## Section 2: Massing and Architecture

2201 N PERSHING DRIVE

**2201 N Pershing Dr  
History of Density/Massing Reductions**

1 MASSING COMPARISON & BUILDING SETBACKS

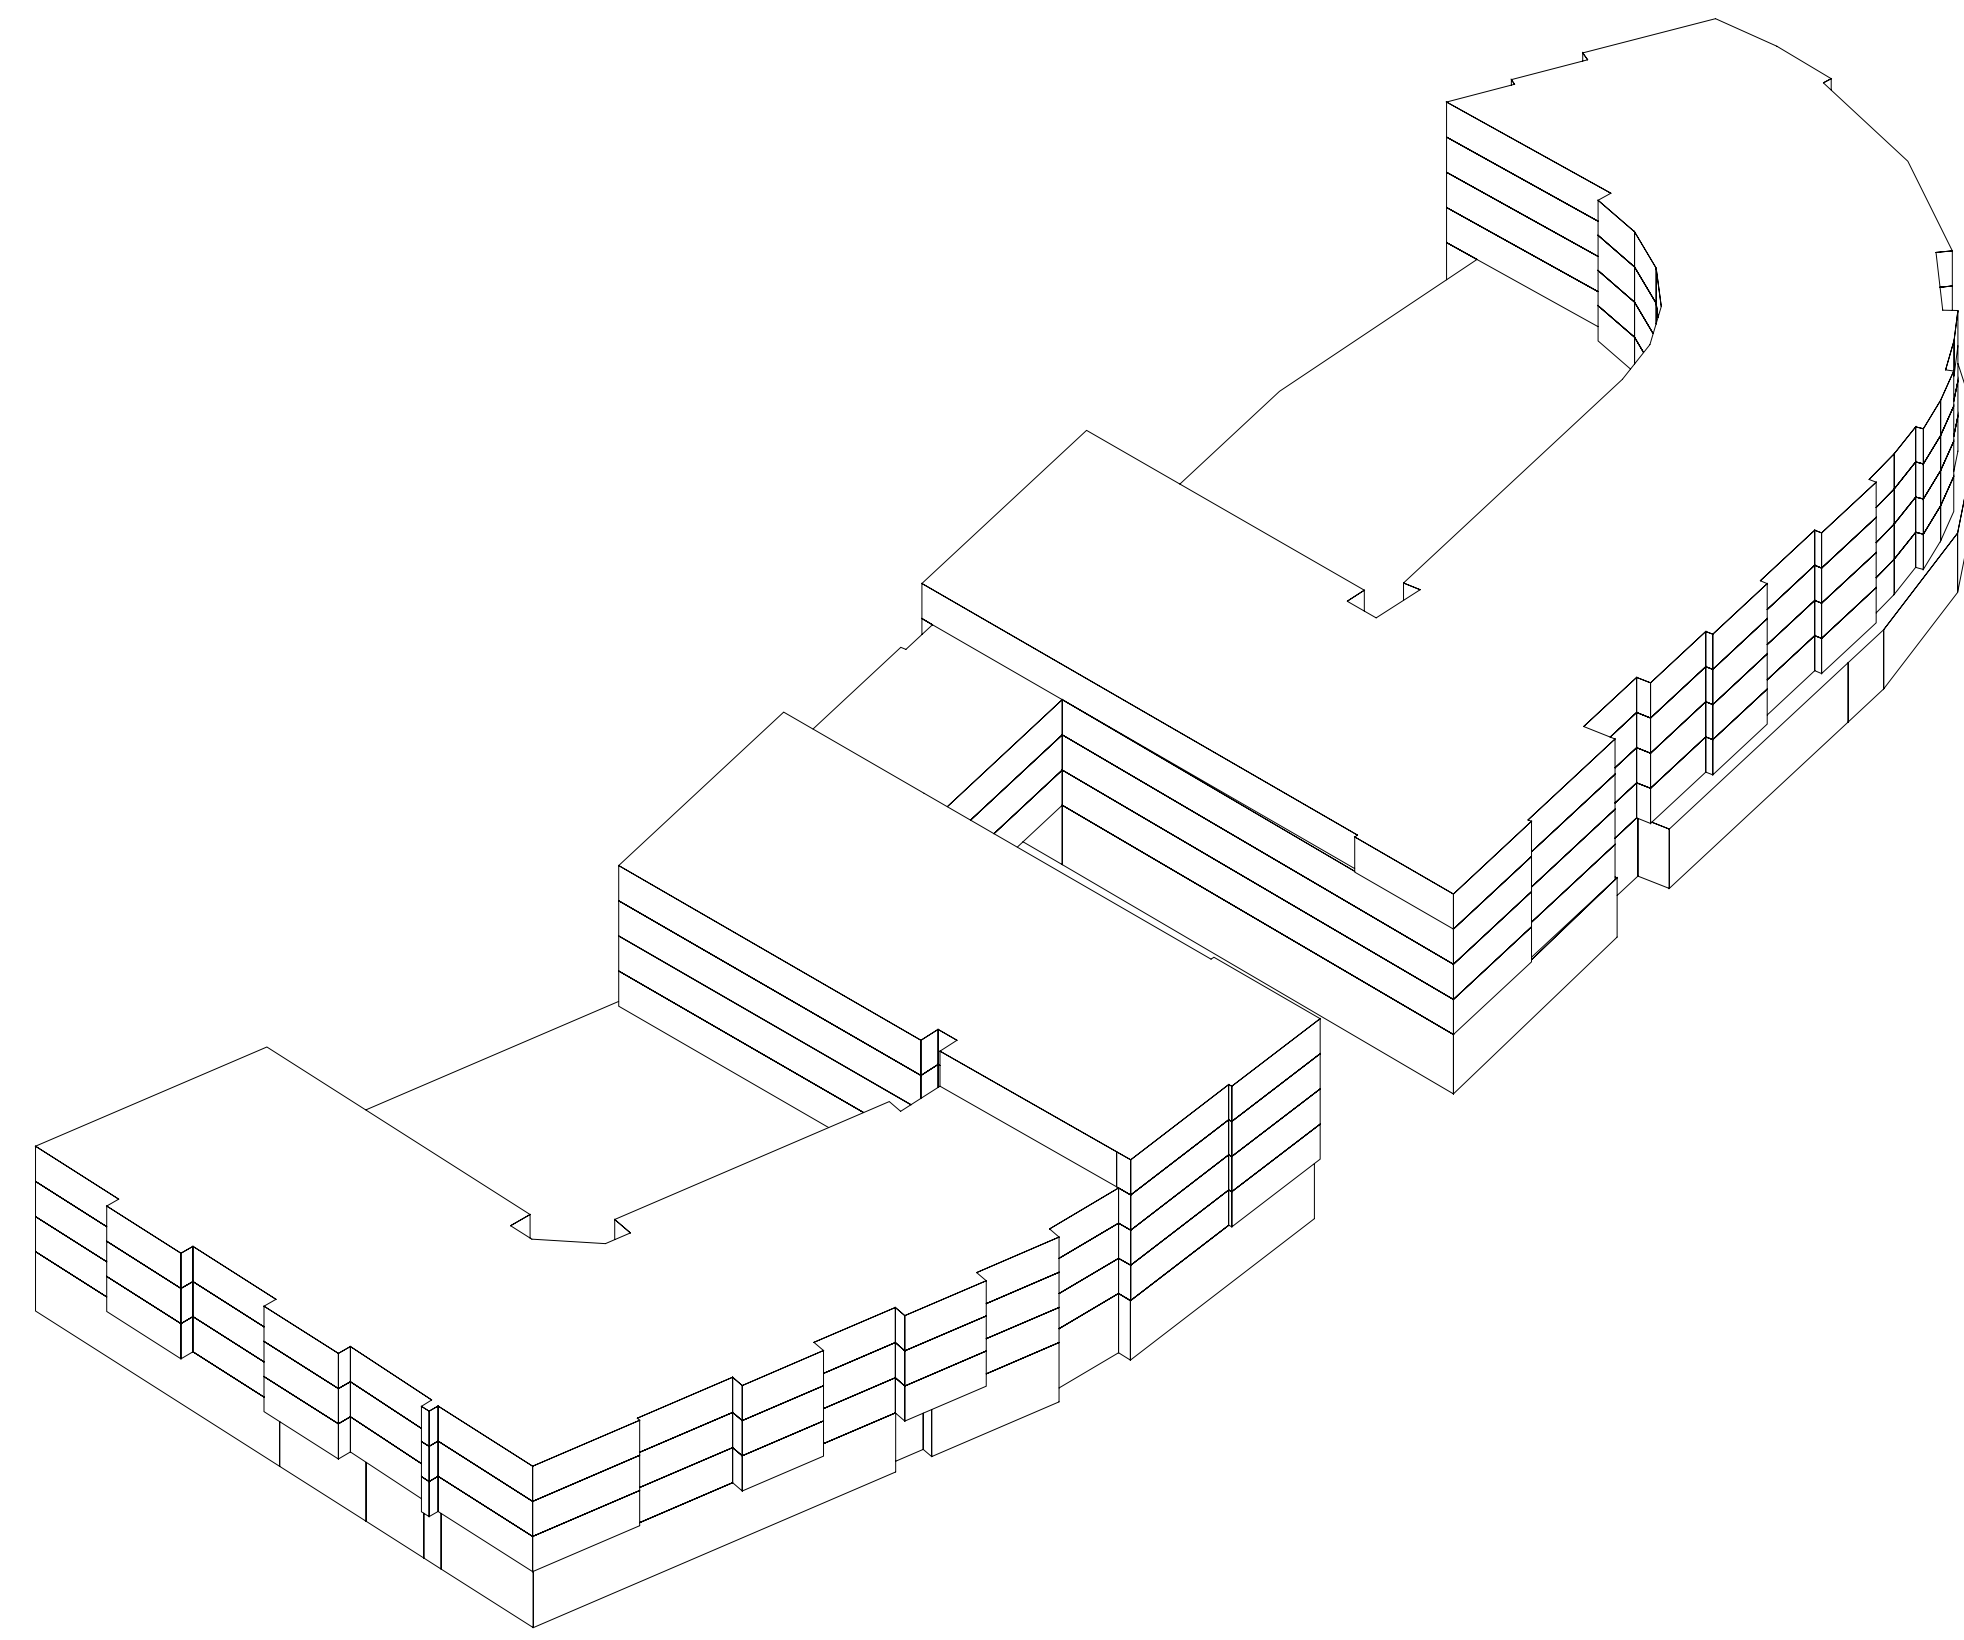
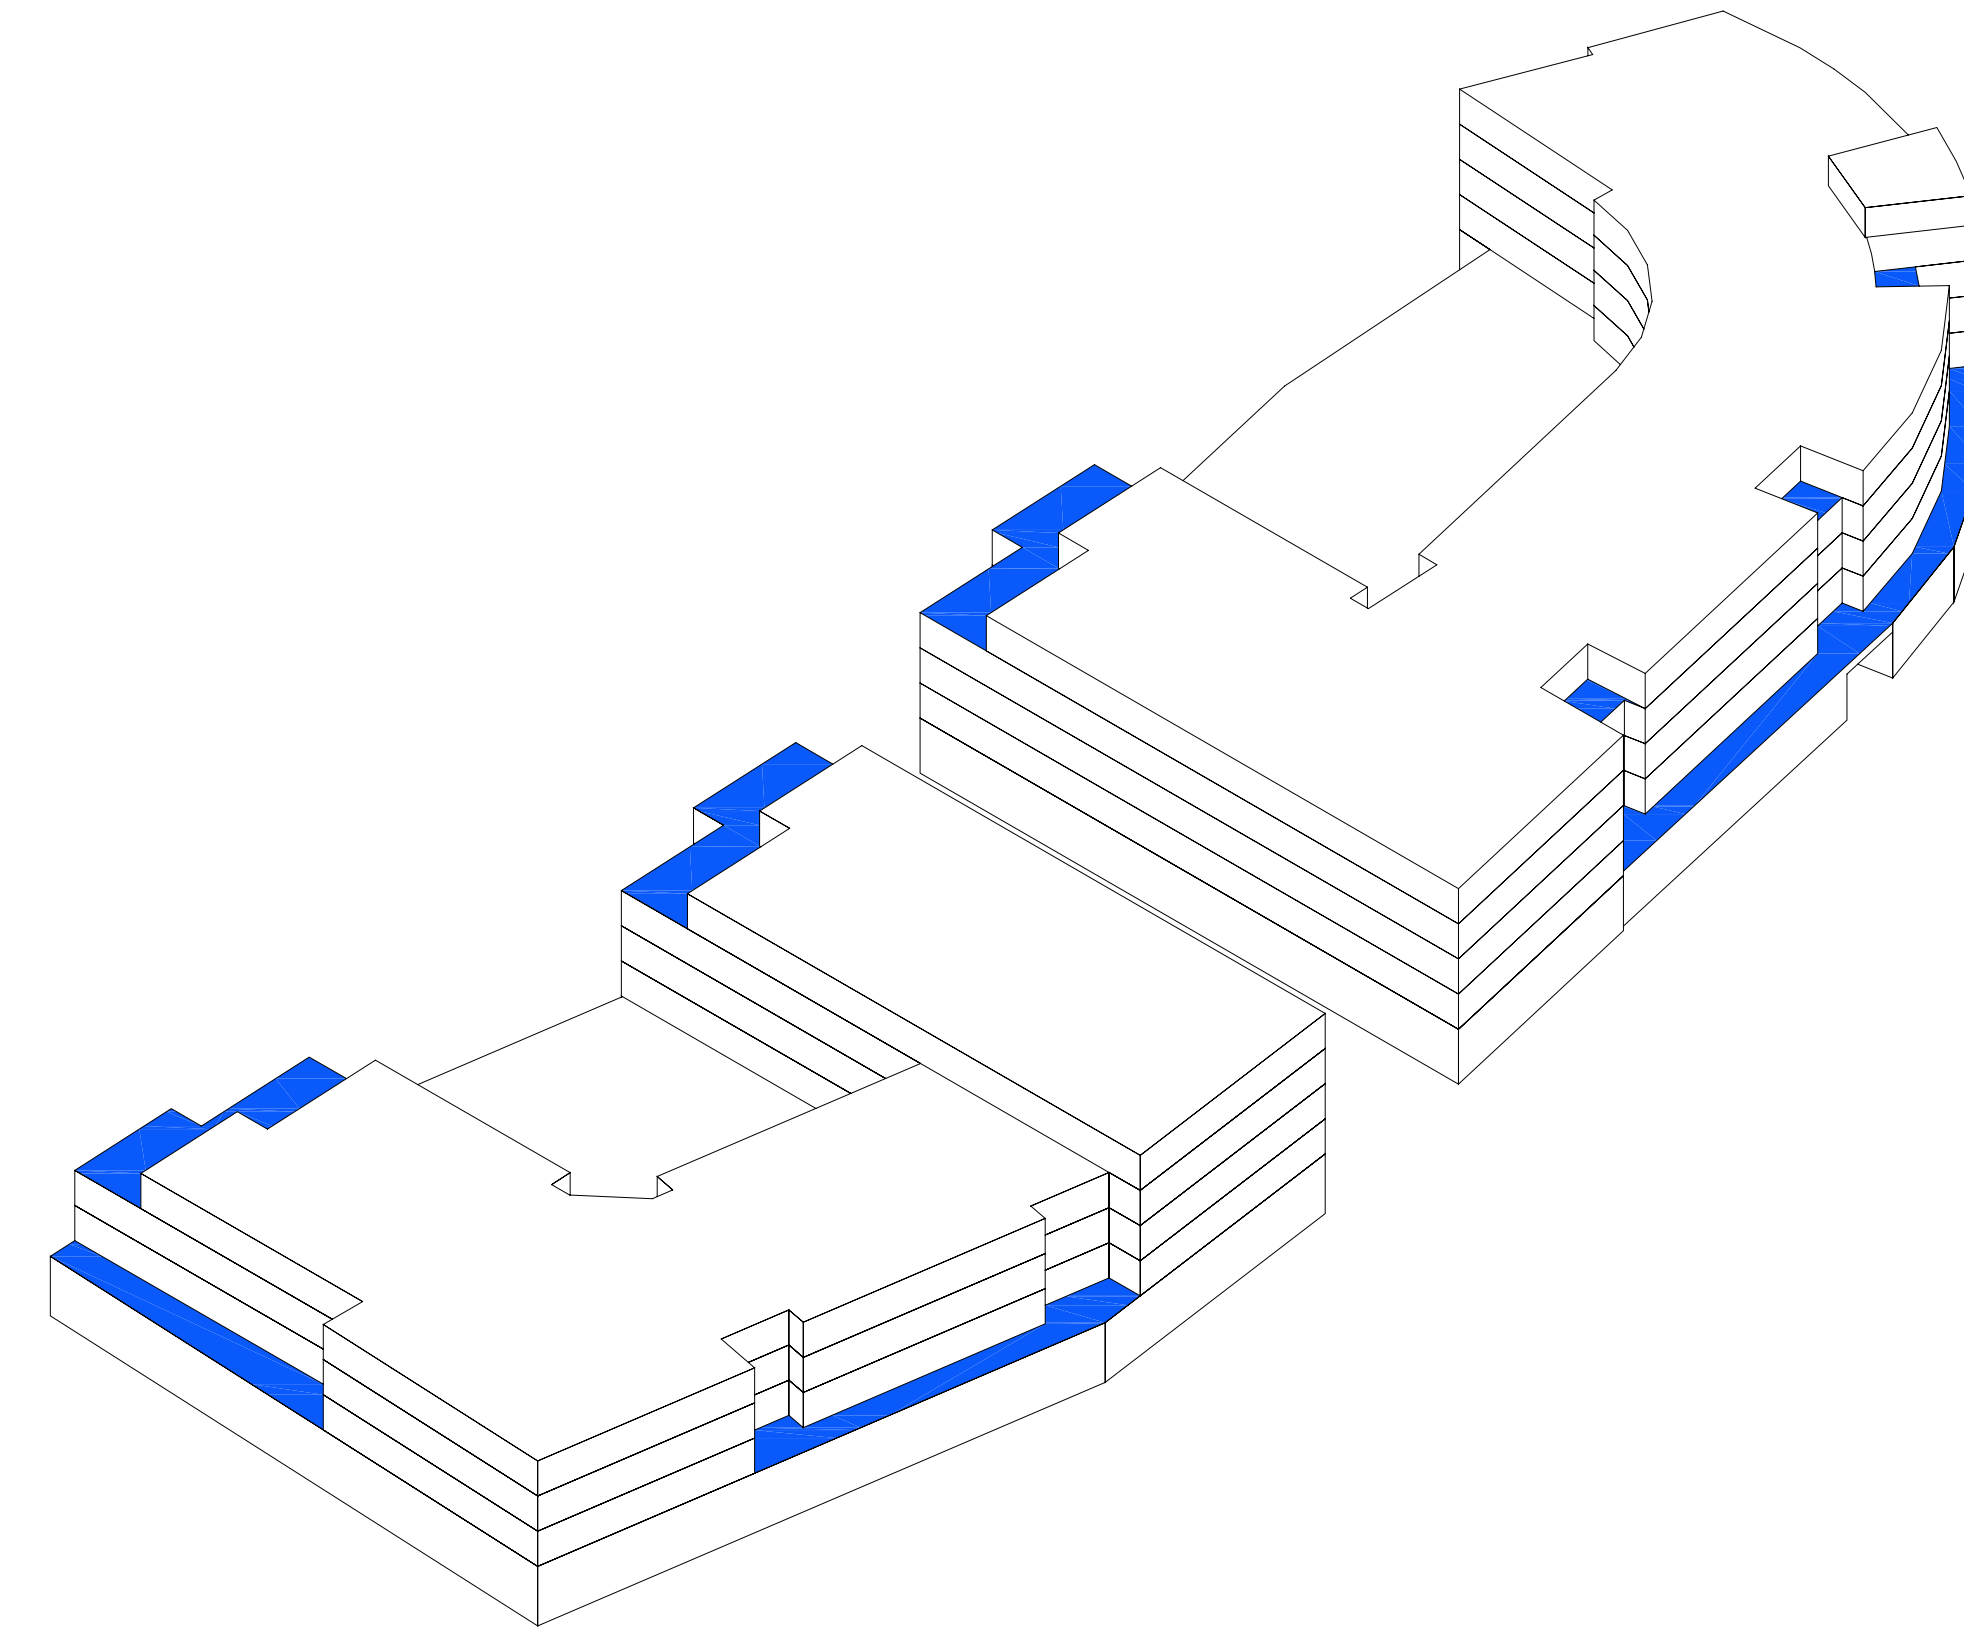
#### **Is the proposed massing compatible with the surroundings?**

**Can the massing be better modulated to create a more varied building form?** There have been a number of changes to the massing of the buildings throughout the review process which have served to reduce the overall scale and intensity of the project. In summary, these changes include the following:

The proposed building massing is comparable to that of surrounding buildings. The Sheffield Court buildings to the north present a continuous building façade of approximately 973 feet along Arlington Blvd, and the building directly to the east on Fort Myer has a length of 301 feet and a width of 128 feet. Our largest building has a length of 302 feet and a width of 80 feet. Furthermore, some of Sheffield Court's buildings rise 4-5 stories above grade along Arlington Boulevard.

- Elimination of the proposed bridge between the two buildings, which reduced the mass and also opened up the view corridor from Wayne Street looking north through the site to the Sheffield Court clubhouse building and cupola.

- Elimination of the fifth floor from Building #1 (the building on the western half of the site).
- Introduction of tiering along the northern property line towards Sheffield Court, with the top floors pulled back 36 feet in certain locations.

- Additional stepping back of the residential use behind the retail base, resulting in setbacks of approximately nine feet on the Pershing Drive façade and seven feet along the western façade of Building #1 (facing Barton Street) to create additional layering of the massing along the streetscape as experienced by pedestrians.

- Introduction of deeper setbacks (14 feet to 19 feet in depth) in five locations along the Pershing Drive frontages to create better building articulation in order to break up the total building mass into a series of smaller, discrete components. At the top floor, these setbacks are further tiered to between 19 and 25 feet in depth to create further articulation on the façade.

- Redesign of the “tower” element facing Arlington Boulevard as a prominent architectural feature for the project.

The net effect of all these reductions and modifications has been to eliminate approximately 34,185 square feet of proposed residential area from the project. This represents more than 14% of the total residential density from the original design. Overall, approximately 58% of the total building footprint is four stories or less if the courtyards above the retail parking are excluded from this calculation. If the courtyards are included, then the proportion of the project at four stories or less increases to 68%.
